VIRGINIA ELECTRIC AND POWER COMPANY
NORTH ANNA POWER STATION UNITS 1 AND 2
SIX-MONTH STATUS REPORT IN RESPONSE TO MARCH 12, 2012 COMMISSION
ORDER MODIFYING LICENSES WITH REGARD TO REQUIREMENTS FOR
MITIGATION STRATEGIES FOR BEYOND-DESIGN-BASIS EXTERNAL EVENTS
(ORDER NUMBER EA-12-049)

**Six-Month Status Report for the Implementation of Order EA-12-049
Order Modifying Licenses with Regard to Requirements for Mitigation Strategies for
Beyond-Design-Basis External Events**

**North Anna Power Station Units 1 and 2
Virginia Electric and Power Company (Dominion)**

**Formal Responses to October 2013
Audit Questions**

FIGURE 13
CONTAINMENT COOLING
BDB FLEX PRIMARY MECHANICAL CONNECTIONS
NORTH ANNA UNIT 1 (TYPICAL FOR UNIT 2)

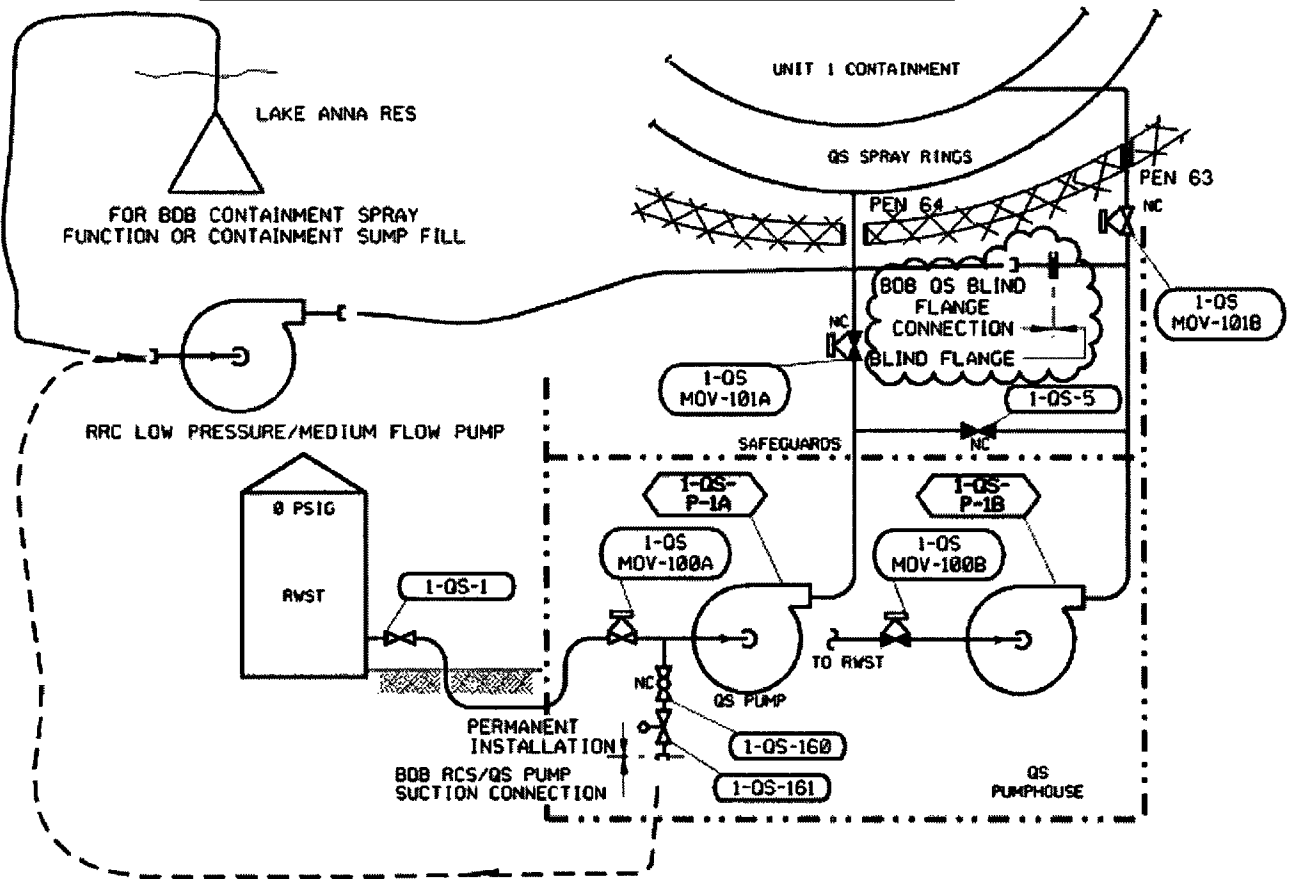
Low Pressure / Medium Flow pump. Water strainers are provided for this use to prevent clogging of the CS ring header nozzles (Refer to Figure 13).

Medium Flow pump connected to the BDB RCS/QS Pump Suction connection, located in the QSPH, and discharging to the BDB QS Blind Flange connection, located in the Safeguards Building, through flexible hoses. The pump will be received from the RRC and staged in the yard area near the RWST. Hoses will be routed to inside the QSPH and Safeguards Building to the BDB connections providing pump suction and discharge flowpaths. See Figure 13.

The Casing Cooling Tank and RWST are not protected from high winds and associated missiles. If these tanks are not available for response to an ELAP, raw water from the Service Water Reservoir or from Lake Anna can be pumped to the BDB QS Blind Flange connection using the BDB High Capacity pump or the RRC Low Pressure / Medium Flow pump. The BDB High Capacity pump would be deployed from the BDB Storage Building and located near the Service Water Pump House or the Intake Structure for suction from the reservoir or lake, respectively. Pump discharge flexible hoses would be routed to the BDB QS Blind Flange connection in the Safeguards Building. Water strainers are provided at the pump suction to prevent clogging of the CS ring header nozzles. See Figure 13. If the RRC Low Pressure / Medium Flow pump is used, the pump

FIGURE 14
CONTAINMENT COOLING
BDB FLEX ALTERNATE MECHANICAL CONNECTIONS
NORTH ANNA UNITS 1 AND 2

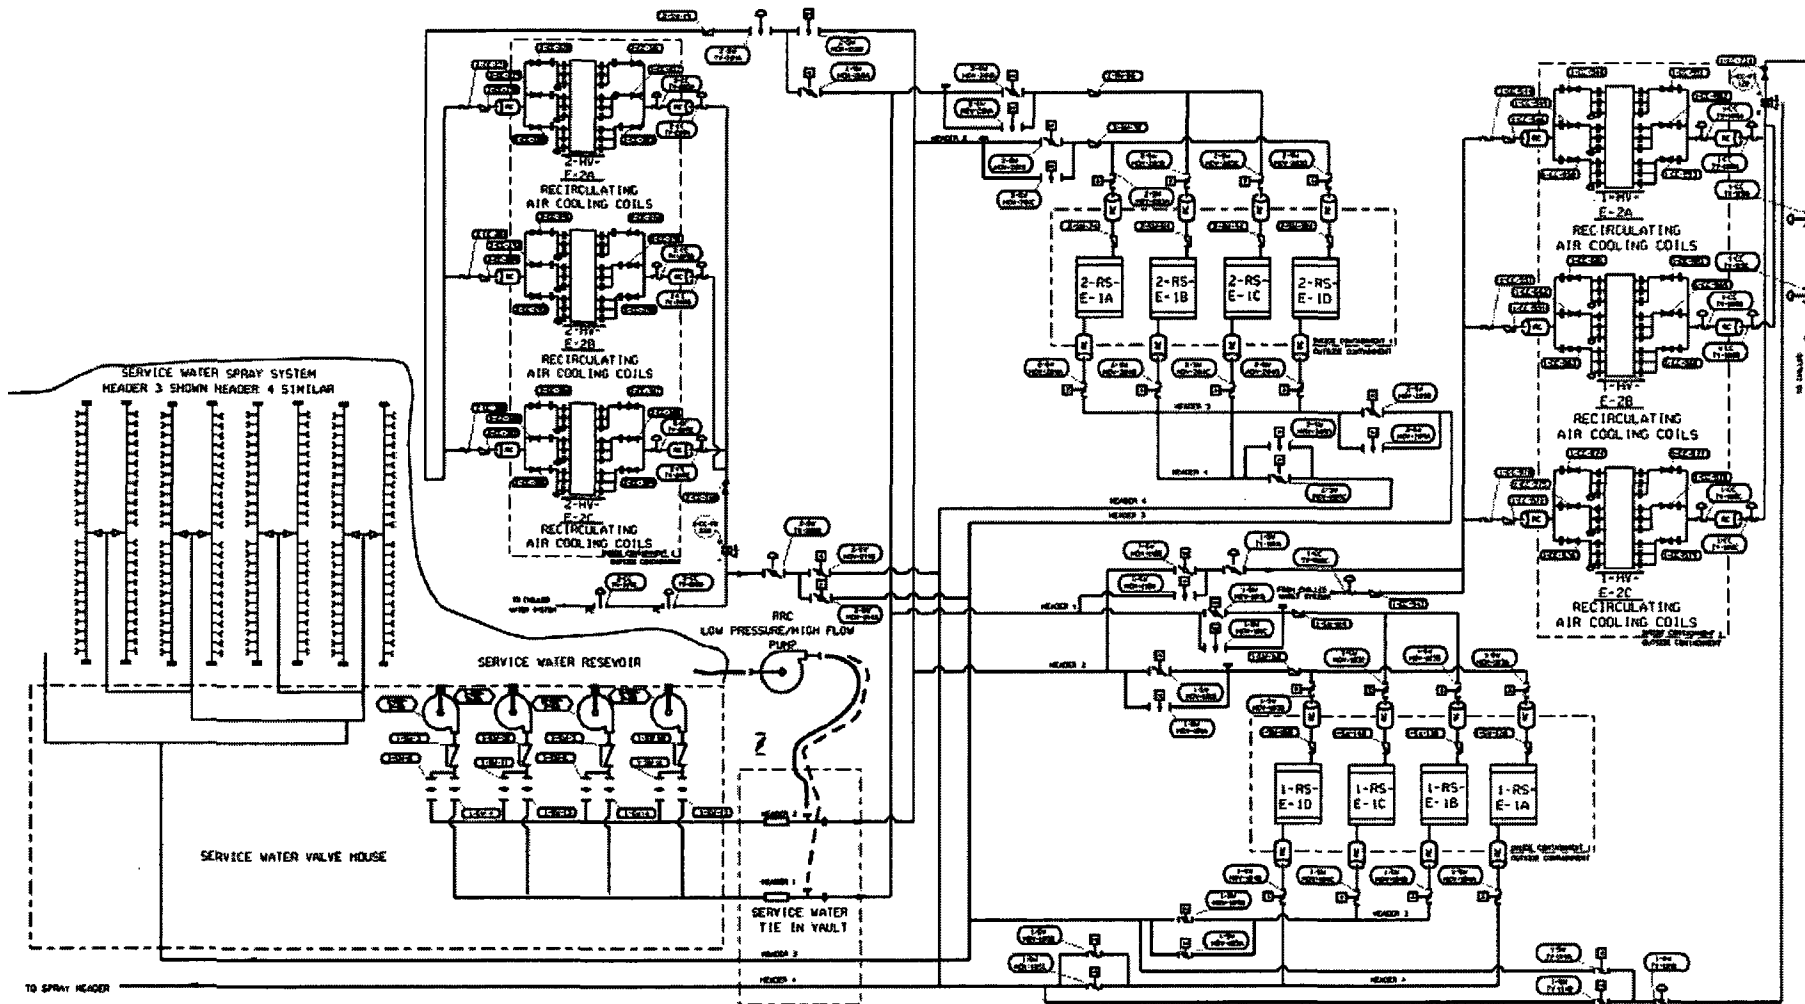
In the event that the Service Water system pumps are unavailable, the SW system can be pressurized by the site diesel-driven Fire Protection (FP) system pump drawing from the Service Water Reservoir, or by a portable RRC Low Pressure / High Flow pump (or two RRC Low Pressure / Medium Flow pumps). The FP pump pressurizes the FP main piping and, through the Auxiliary Feedwater (AFW) pump supply connection, can be aligned to flow to the SW system and provide cooling water flow through the RS heat exchangers. The FP pump is adequately sized to provide flow to the turbine-driven AFW pump suction (described in Section B.1) and flow to the RS heat exchangers. **[Open Item 5]** Alternately, a portable RRC Low Pressure / High Flow pump (or two RRC Low Pressure / Medium Flow pumps) will be located near the Service Water Chemical Addition Building to draw from the Service Water Reservoir and discharge to the SW system via a flanged opening in the 36" piping in the Service Water Pump House Expansion Joint Vault using a hose adapter (see Figure 14).

In the event that the Service Water system pumps are unavailable to provide cooling water flow to the RS heat exchangers, the SW system can be pressurized by the installed diesel-driven Fire Protection (FP) system pump drawing from the Service Water Reservoir, or by a portable RRC Low Pressure / High Flow pump (or two RRC Low Pressure / Medium Flow pumps). If used, the portable RRC Low Pressure / High Flow pump (or two RRC Low Pressure / Medium Flow pumps) will be received from the RRC and staged near the Service Water Chemical Addition Building to draw from the Service Water Reservoir and discharge to the SW system via a flanged opening in the 36" piping in the Service Water Pump House Expansion Joint Vault using a hose adapter. Flexible hoses will be routed from the pump discharge to the hose adapter. See Figure 14.

cooling using installed plant equipment and portable pumps. In the event that the SW pumps are unavailable, cooling water flow to the CC heat exchanger will be established by pressurizing the SW system as described for the primary Containment cooling strategy. See Figure 14.
